Eng: David Nundie PCB1870788 <User Ext.83> <User Ext.84> <User Ext.85>		Paul. C. Buff Inc. 2725 Bransford Ave. Nashville, TN 37204	
Sheet Title: HX2000Radio.sch		RadioRenote One RFTX	
Sheet Creation date: 03/26/99	Sheet B	Sheet 1820788	Sheet E
10/12/99		SHEET 4 OF 5

Optional Resistor to Reduce TX Power

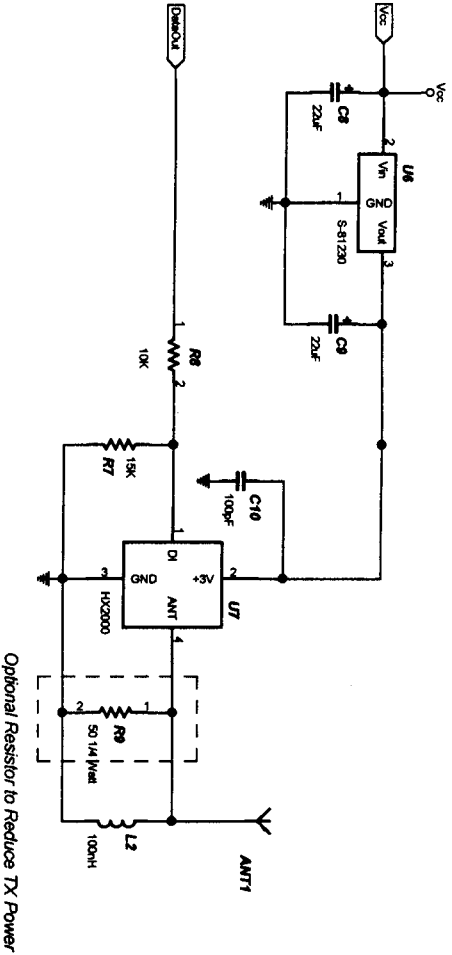
Revision History
 Rev A Change R6 from 10K to 1K
 Rev B Change R6 on Sheet 4 from 1K to 15K
 and connect to ground instead of +3V
 Add R7 10K in series with DO pin on HX2000
 Rev C Change 10uF caps to 22uF in PS circuits
 Rev E Add Antenna Power Shunt Resistor R9
